This page lists the know errors on the gm5x5x5 PCBs. There are no known issues with the bulk order run (white pcbs), the following information is valid **only** for the prototype run (green pcbs).

Prototype Run

#1 MIDI IO pins

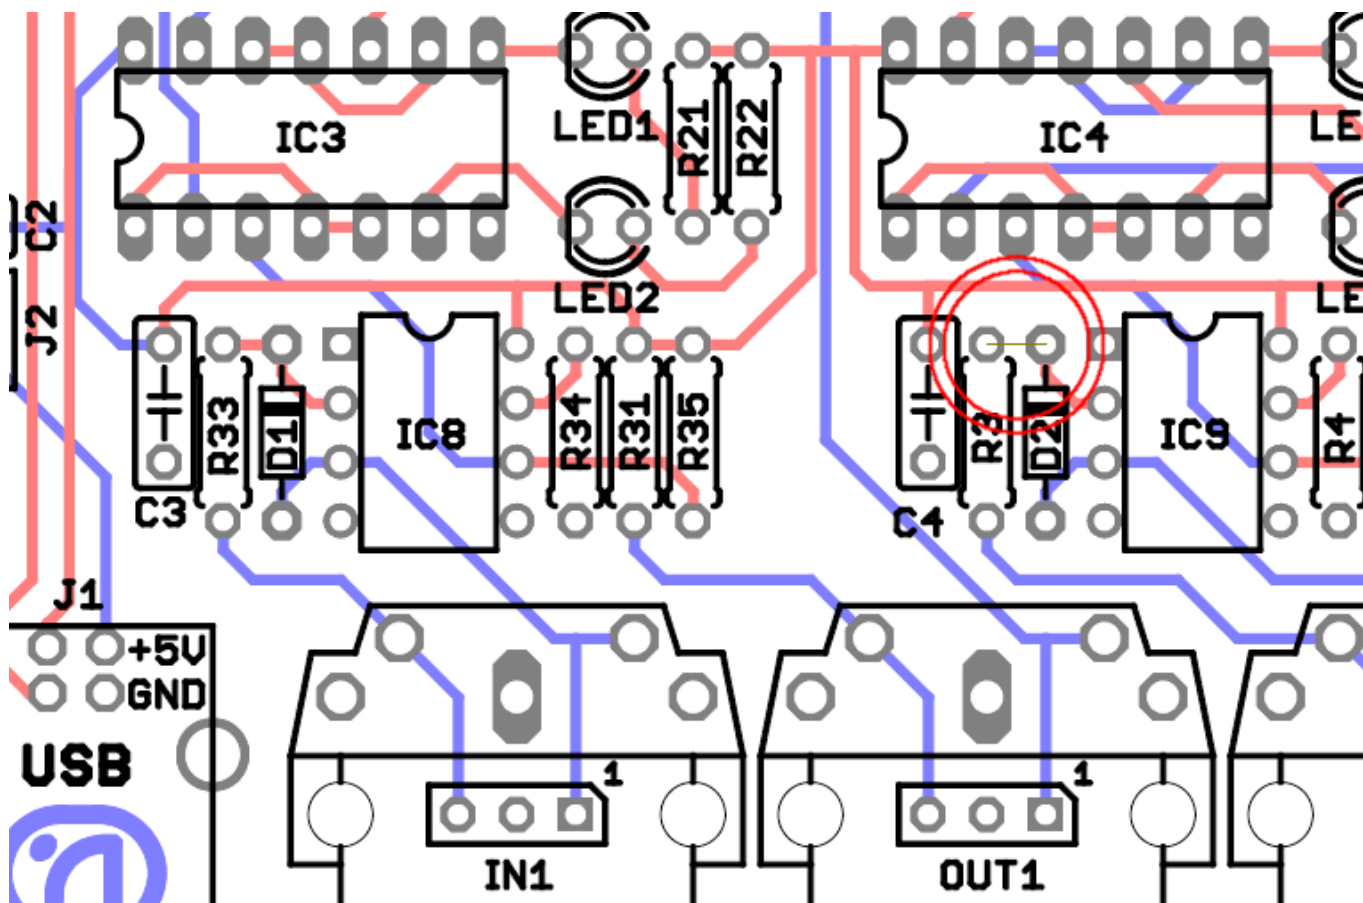
Problem: The MIDI IO pins of the midi sockets (Pin 4 + 5) are switched.

Solution: Either (1) use the pin-headers if you use sockets that are not mounted on the pcb or (2) break the traces to pins 4 + 5 of the sockets and solder wires to them or (3) solder the midi sockets on the other side of the pcb.
